## Product Change Notice (PCN)

PCN Number: PCN-0456173R-01

Product(s) Affected: PJ-040DH

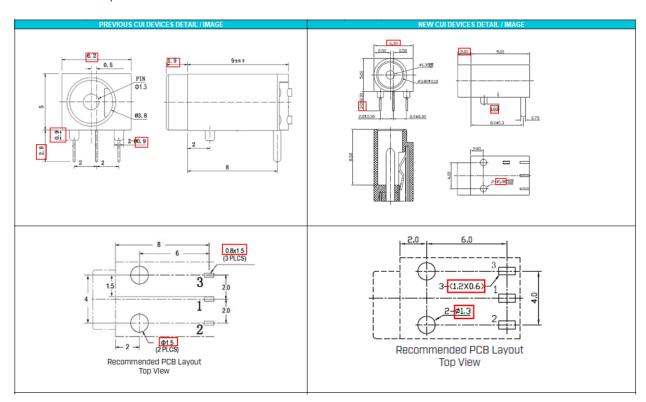
Description of Change: New Factory Location. Product re-engineered for improved manufacturability and production yield. See image below for reference and check CUI Devices website for updated drawing. Cosmetic differences may be visible and not affect the form fit and function of the product.

PREVIOUS CUI DEVICES DETAIL / IMAGE			NEW CUI DEVICES DETAIL / IMAGE		
DESCRIPTION	MATERIAL	PLATING/COLDR	DESCRIPTION	MATERIAL	PLATING/COLOR
center pin	brass	silver	center pin	brass	silver
terminal 1	brass t=0.25	silver	terminal 1	brass t=0.25	silver
terminal 2	brass :=0.25	silver	terminal 2	SUS301 t=0.25	silver
terminal 3	brass t=0.25	silver		brass t=0.25	
cover	PBT (UL94V-0)	black	terminal 3		silver
housing	PBT (UL94V-0)	black	housing	PA66 UL94V-0)	black
Ø3.5  Ø1.35  MATING PLUG  Jack Insertion Depth: B.0 mm			MATING PLUG Jack Insertion Depth 8.5 mm
